RE: RESPONSE TO REQUEST FOR FURTHER INFORMATION – 757 – 763 GEORGE STREET, HAYMARKET

This letter has been prepared on behalf of Samprian Pty Ltd (the Applicant) in relation to their land at 757 – 763 George Street, Haymarket (the site). The site is the subject of a Planning Proposal (PP ref no PP-2020-1110.) that seeks to amend the height of buildings and floor space ratio (FSR) development standards that apply to the site under the *Sydney Local Environmental Plan 2012* (Sydney LEP 2012). The purpose of this letter is to respond to the matters raised by the City of Sydney (Council) in their Request for Information letter dated 12 November 2022.

757-763 George Street Sydney

Figure 1 - Wind testing locations and compliance with wind comfort and safety criteria

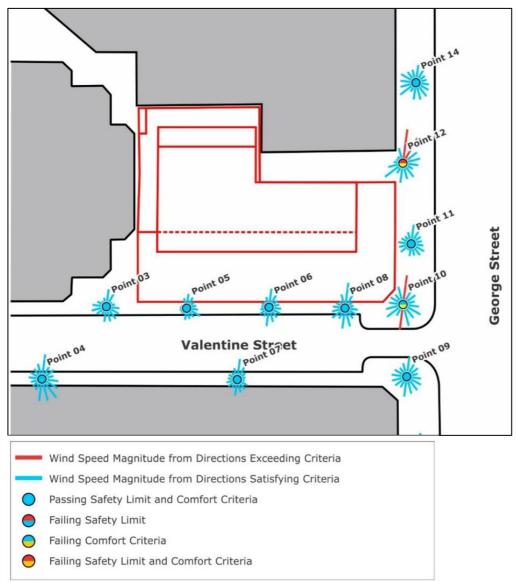
Issue (summary): The proposed envelope results in a windy environment, including two locations with a wind comfort rating of 'uncomfortable' and an exceedance of the wind safety standard. While meeting the average wind criteria is important, it is not the sole determinant of an appropriate response to wind. Accordingly, it is recommended that additional wind testing is undertaken to identify opportunities for wind mitigation including amending the planning envelope geometry, to help calm these locations.

Council identified that two testing locations fail to meet the wind comfort rating and exceed the wind safety standard. These testing point locations consist of **Point 10** and **Point 12** which are identified in **Figure 1** below.

The wind testing results conclude that Points 10 and 12, as shown in **Figure 1** below, exceed the relevant criteria thereby resulting in a minor non-compliance with Section 5.1.9. Specifically:

- Point 10 provides a minor exceedance to the wind speed comfort criteria; and
- Point 12 provides a minor exceedance to the wind speed and safety criteria.

- Windtech have undertaken further wind testing (**Appendix 2**) to assess whether the proposal is capable of complying with Section 5.1.9. The results confirm that the proposal, and specifically Points 10 and 12, is capable of achieving full compliance with the applicable wind provisions subject to minor design changes and mitigation measures, including the existing heritage awning and a small building chamfer along the north-eastern corner of the podium. These are discussed further below.

- With the existing surrounding buildings and the inclusion of the Proposed Case massing with the heritage awning and a small building chamfer along the north-eastern corner of the podium, the results of the study demonstrate that wind conditions for all trafficable outdoor locations within and around the development will be suitable for their intended uses and comply with Section 5.1.9.

01 - Wind results

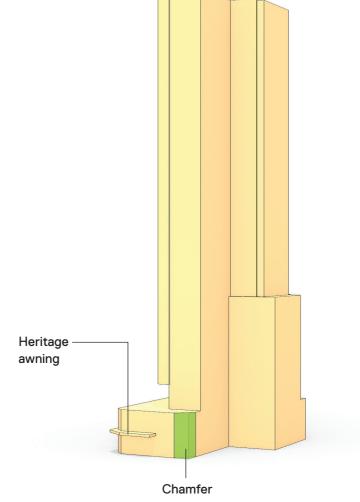
Two locations with a wind comfort rating of 'uncomfortable' and an exceedance of the wind safety standard.

Suggestion:

Additional wind testing to identify opportunities for wind mitigation, including amending the planning envelope's geometry to help calm these locations.

As requested by Council we have undergone further wind tunnel testing to prove how the envelope can achieve compliance and eliminate the minor exceedences to Points 10 and 12.

Windtech's study proved that Point 10 will be pass with the inclusion of the heritage awning above.

For Point 12, a small chamfer at the podium level of $3.58 \,\mathrm{m} \times 3.58 \,\mathrm{m}$ is enough to make the test point compliant. It is worth noting that this area has already been removed in the indicative scheme and as such would not have an impact on the available FSR.

Schedule 12 Comparison

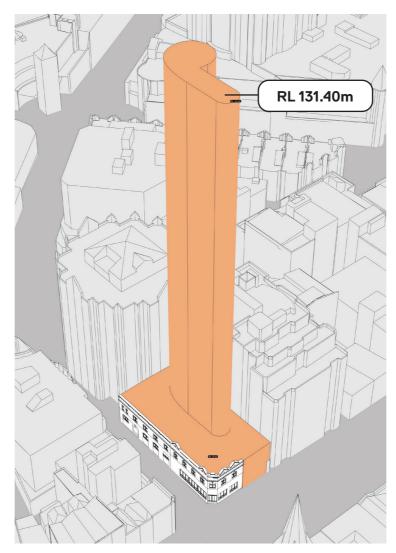
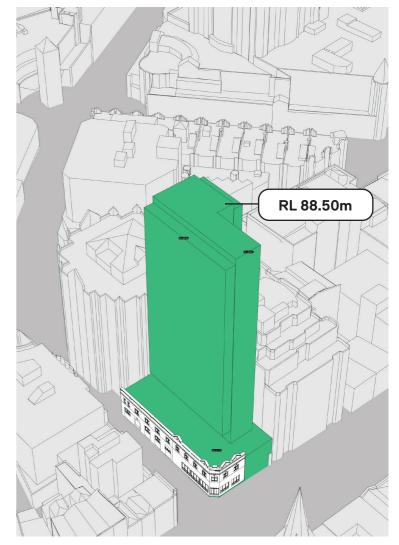
Issue (summary): Overall, the revised planning envelope is highly constrained and does not include sufficient flexibility to address environmental amenity issues. In particular, the planning envelope does not meet the architectural articulation quotient of include a suitable façade zone as required by the draft Central Sydney DCP.

In the amended information, the locations identified as architectural articulation are not actually located within the proposed envelope and therefore cannot be accepted. It is recommended that a minimum of 15% architectural articulation is included within the proposed planning envelope, calculated per floor to ensure there is sufficient flexibility within the envelope on each floor, not volumetrically. Further an appropriate façade zone for sun shading is to be included.

As requested by Council we undertook additional Schedule 12 analysis to compare the scheme against the current regulation.

For consistency the proposed envelope maintained the same setbacks as lodged October 2021.

While the updated regulation allows for an articulation zone of 8% inclusive of facade zone for buildings up to 120m, the requirement for filleting to all corners of the base case massing reduces the envelope significantly.
